### **IN THE DRAWINGS**

Corrected drawings are supplied herewith.

Fig. 1

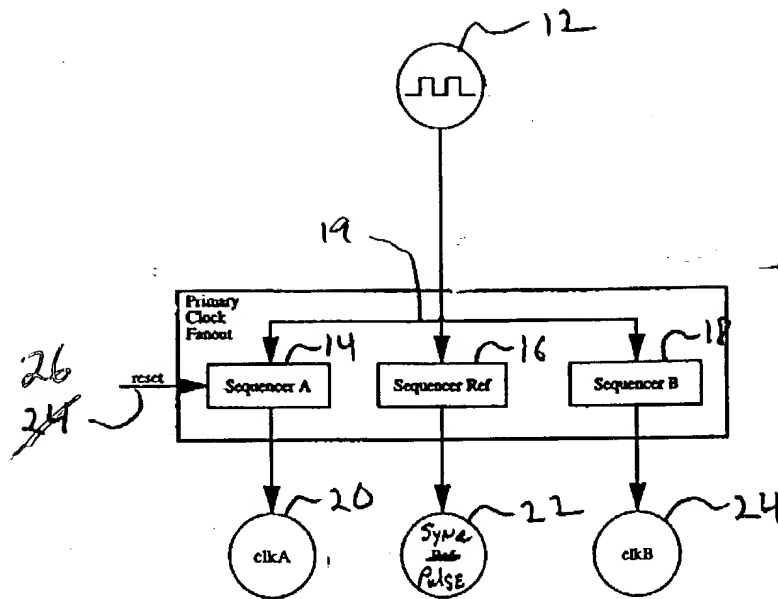
The drawings were objected to because in Fig. 1 the reset is labeled 24 while in the specification the reset is labeled 26. The label in Fig. 1 has been as per the attached red-lined drawing.

Fig. 8

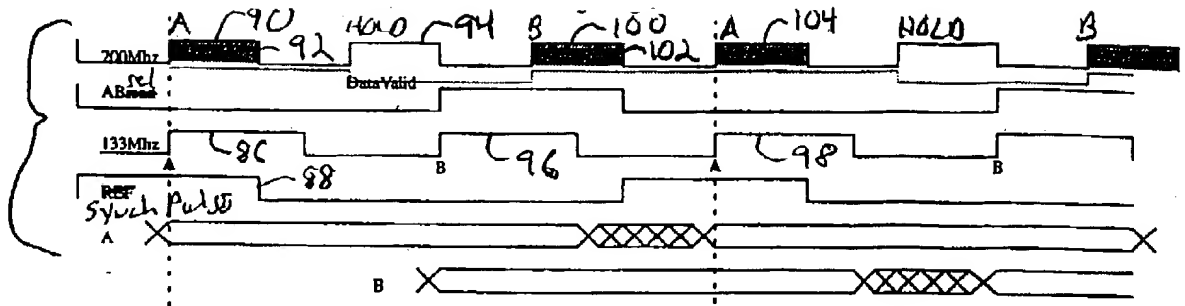
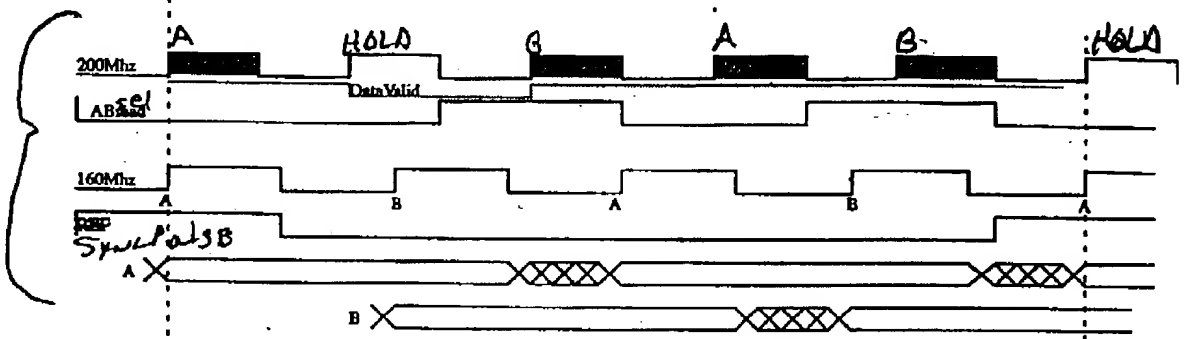
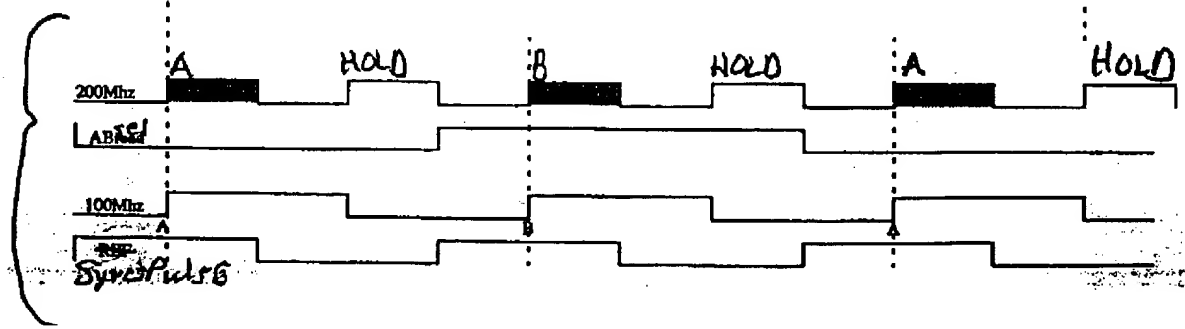
The drawings were objected to for failing to comply with 37 CFR 1.84(p)(5) because they include the following reference sign(s) not mentioned in the description: ref. 108. Applicant was unable to find a reference number 108. A copy of Fig. 8 without the reference number 108 is attached.
